FCC CLASS II PERMISSIVE CHANGE REQUEST LETTER

RE: FCC Permissive II Change Request for Company: TCL Technoly Electronics(Huizhou) Co., Ltd. **FCC ID:** ZVA15

Original FPC antenna:

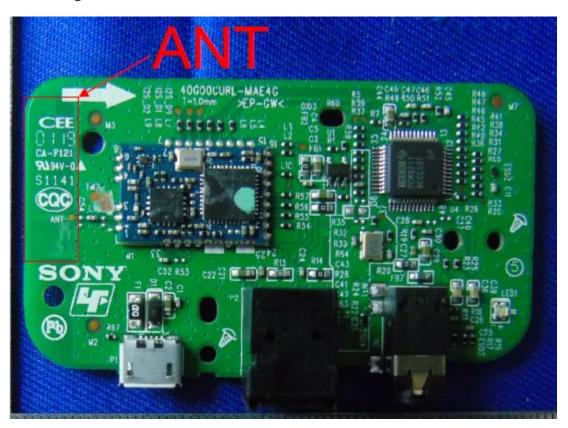
Just the antenna type and gain are different. The original antenna type is FPC, the update antenna type is PCB, please see the picture as below.

FPC antenna IPEX-FPC(90mm) Gain: 3.23dBi; FPC antenna IPEX-FPC(360mm) Gain: 2.92dBi;
